# SAMPLING AND ANALYSIS PLAN CHARACTERIZATION OF THE 903 PAD/RYAN'S PIT AND EAST TRENCHES PLUMES

**ADDENDUM TO  
SAMPLING AND ANALYSIS PLAN  
CHARACTERIZATION OF THE  
903 PAD/RYAN'S PIT AND  
EAST TRENCHES PLUMES**

**Colorado Department of Public Health and Environment  
Hazardous Material and Waste Management Division  
comments on**

**Sampling and Analysis Plan  
Characterization of the 903 Pad/Ryan's Pit and East Trenches Plumes  
Received March 13, 1998**

**FIGURE 2**

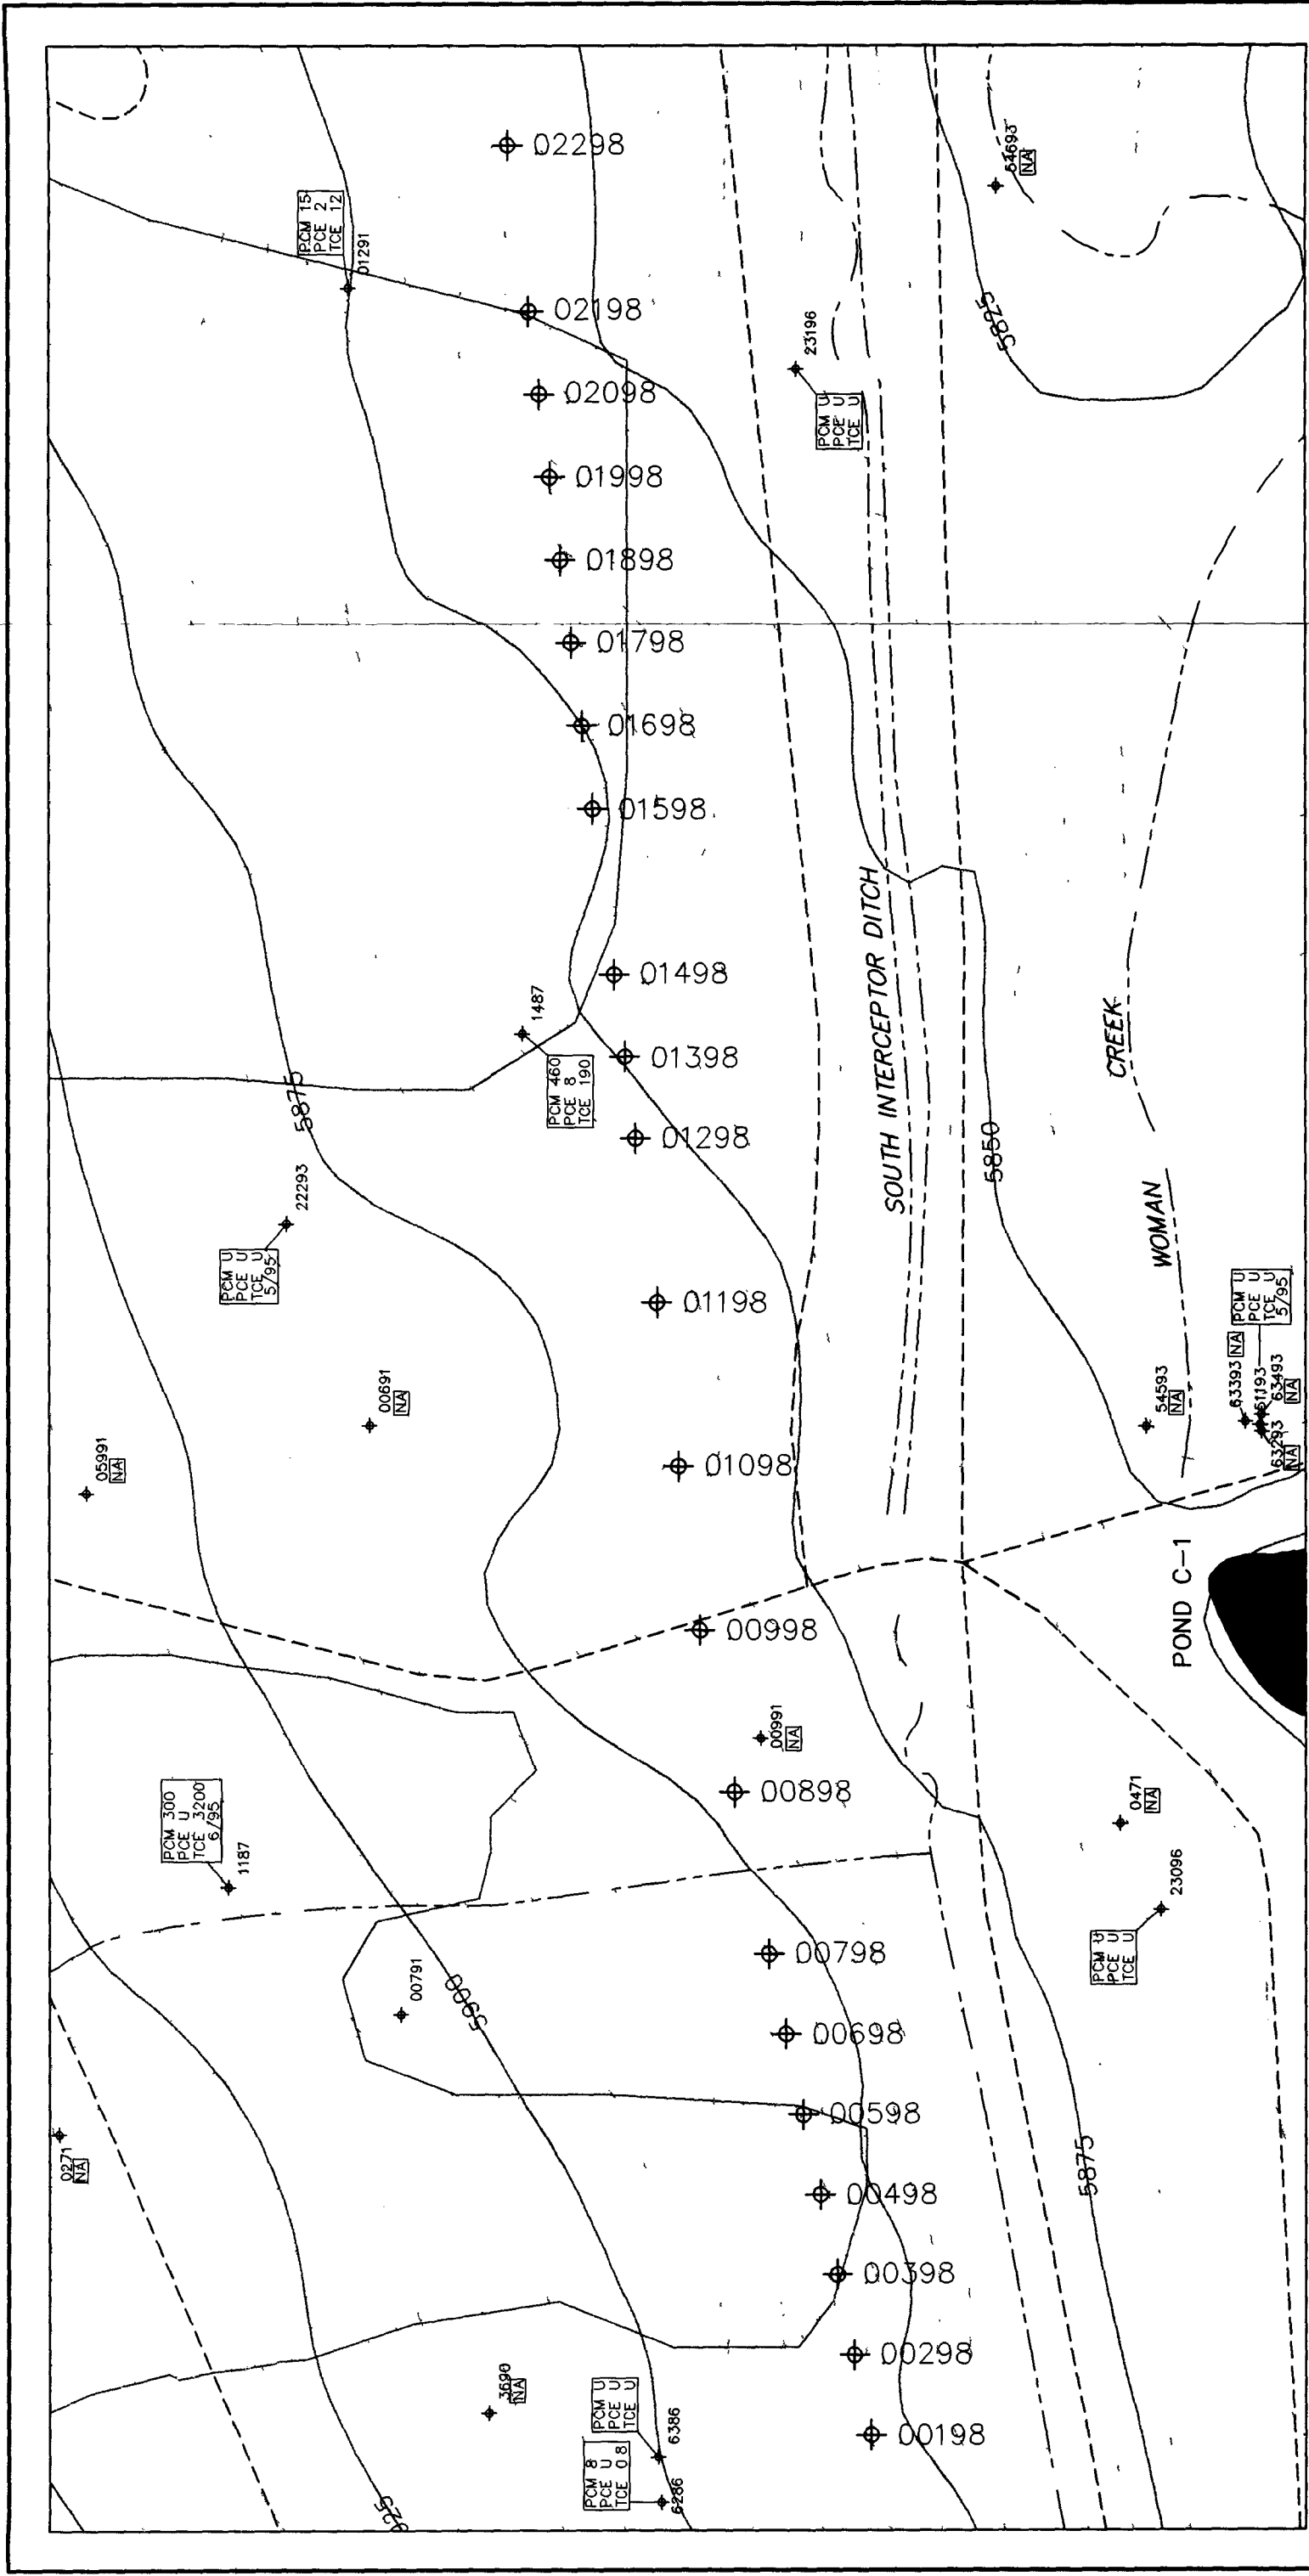
- 1 Proposed Well 02998 must be relocated due to ecological concerns. The new location will be determined in the field and based on field observations and site constraints. Prior to installing Well 02998 the rationale for selecting the well location will be discussed with the regulators.

- 2 All the wells represented within the boundaries of Figures 2 and 3 are labeled with the groundwater concentration data. If analysis was not available, the well was either labeled with "NA" for no data available, or "DRY" if no water was present. The wells originally in question, 02697, 02797 and 02897 have been labeled.

TITLE  
FIGURE 3

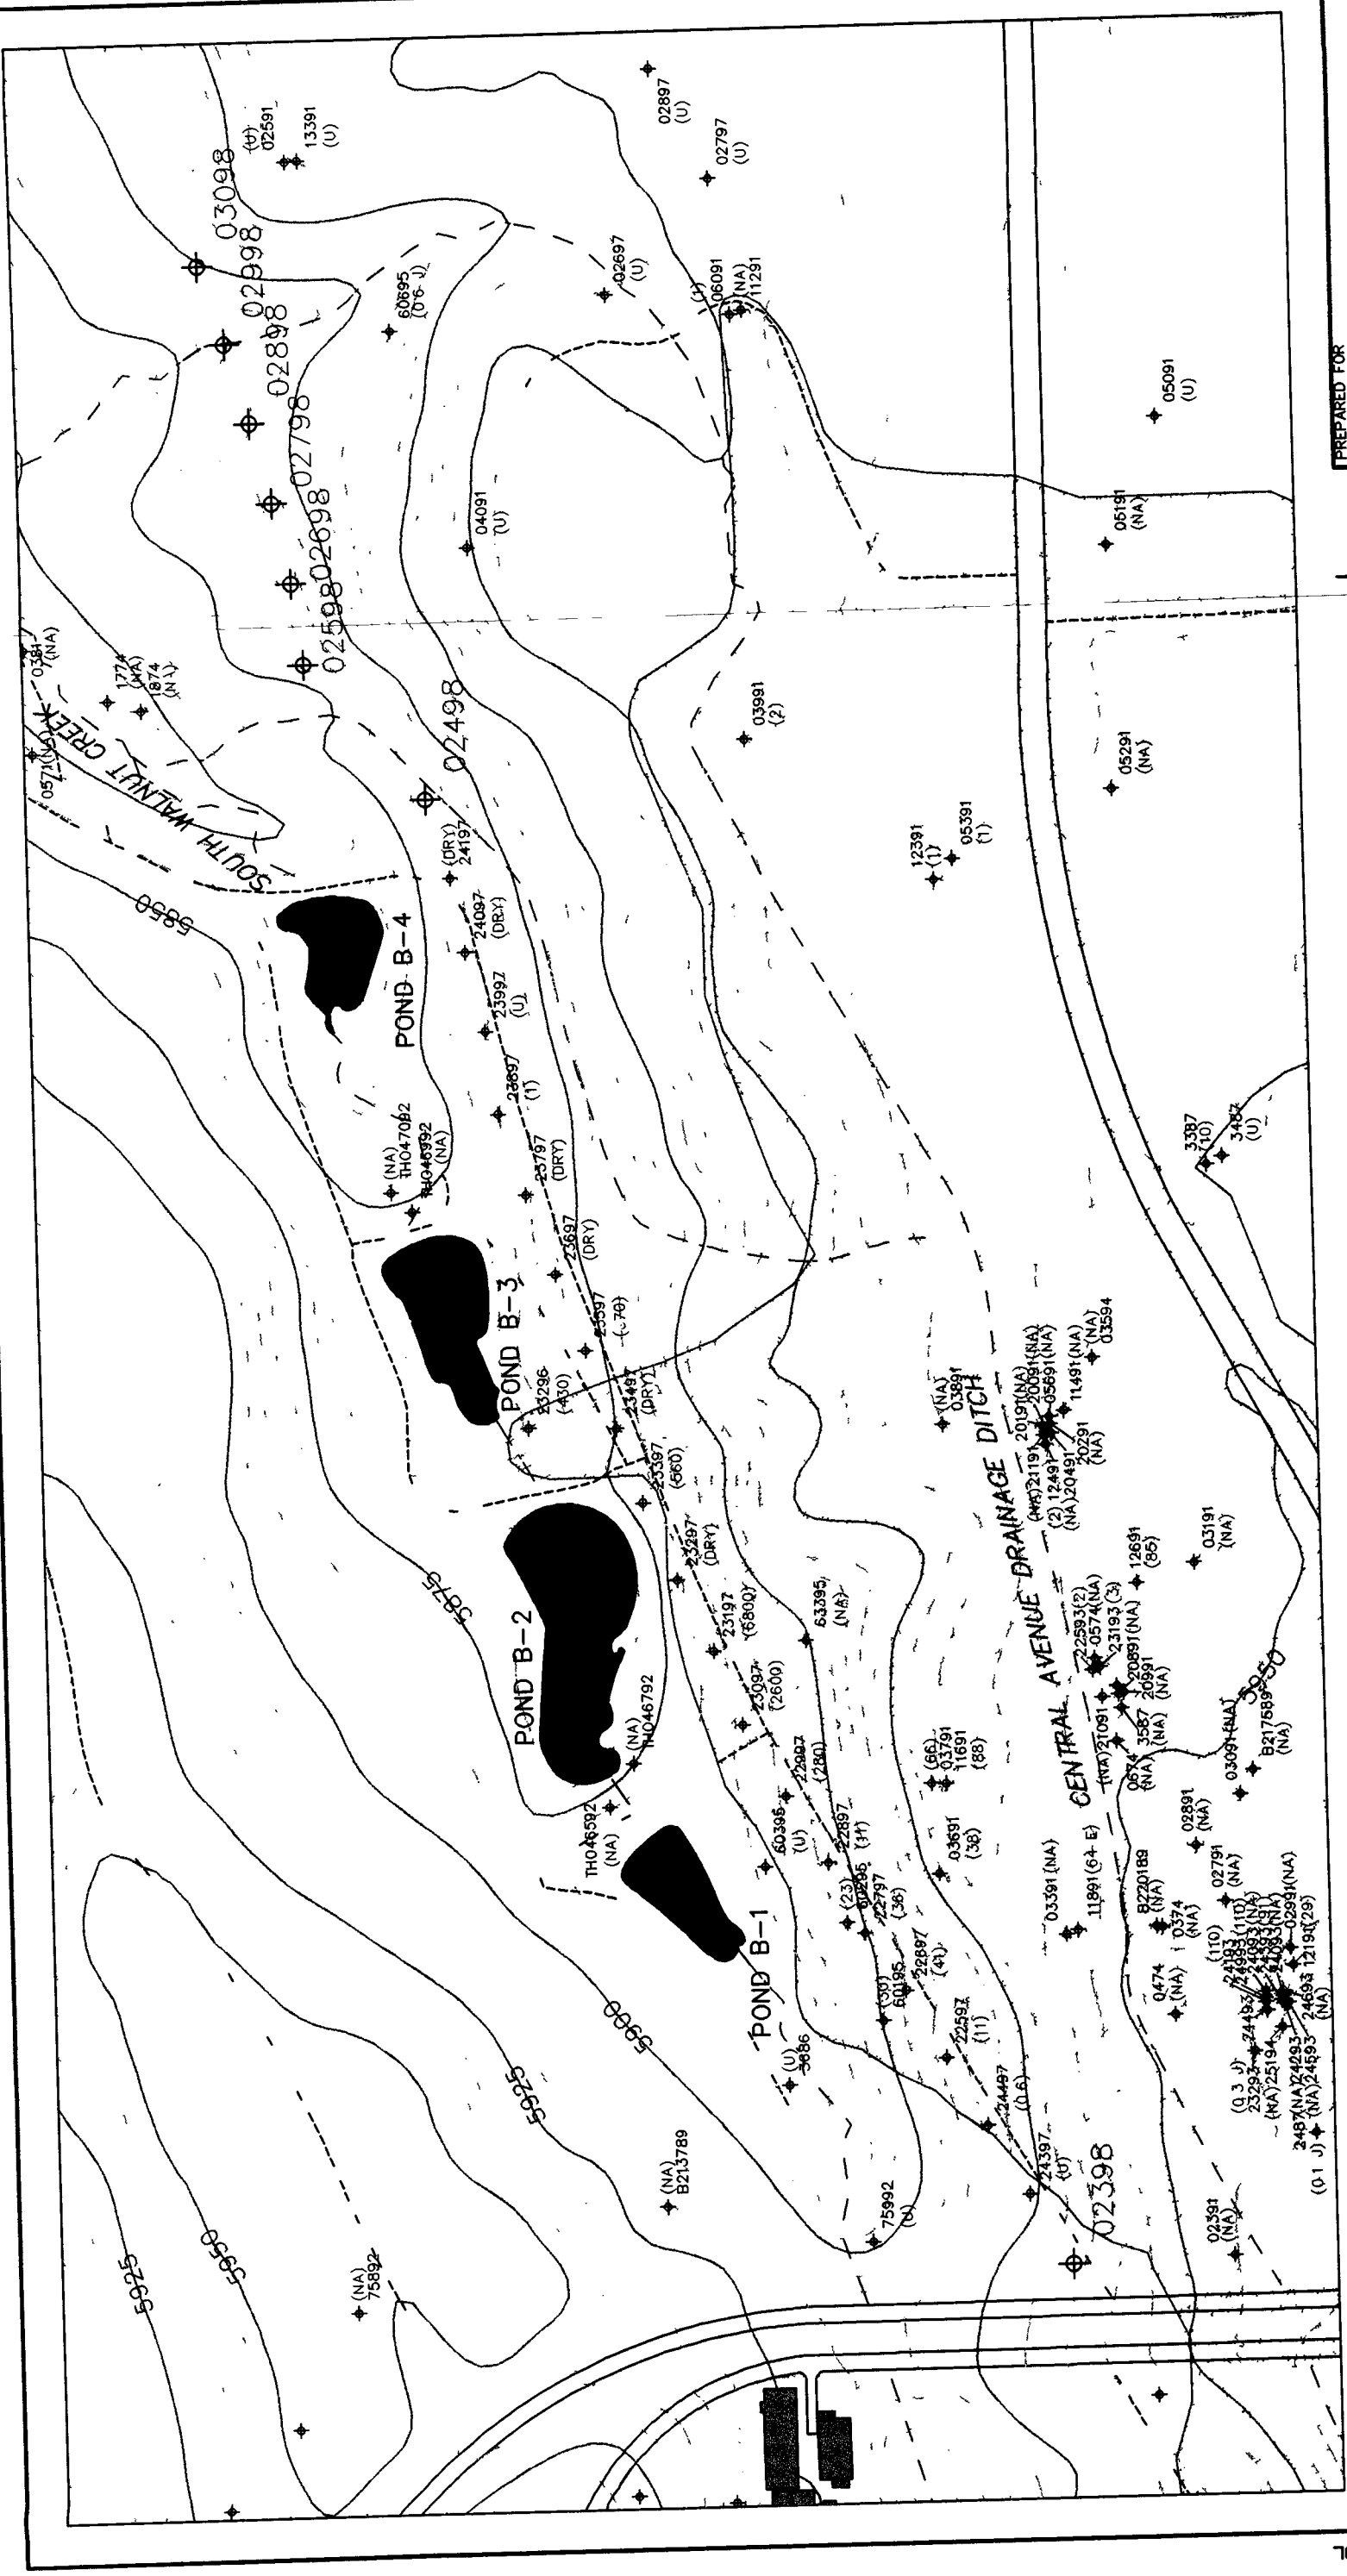
- 11 Figure 3 has been changed, the Tier I plume configuration located in the south central part of the figure, east of wells 20091 and 05691 was removed, as current data does not support Tier I concentrations in this area

Figure 3 presents recent concentrations of trichloroethene in groundwater for a portion of the East Trenches Plume. Also shown is the extent of the VOC plume as defined by an exceedance of the Tier II action level for one or more plume constituents, as presented in the 1996 Annual RFCA Groundwater Monitoring Report (RMRS, 1997b). The plume extent shown does not incorporate 1997 data from the recently installed geoprobe wells. The boundary of the plume exceeding Tier II action levels is not shown. The characterization letter report (item 7) will include revised plume boundaries.
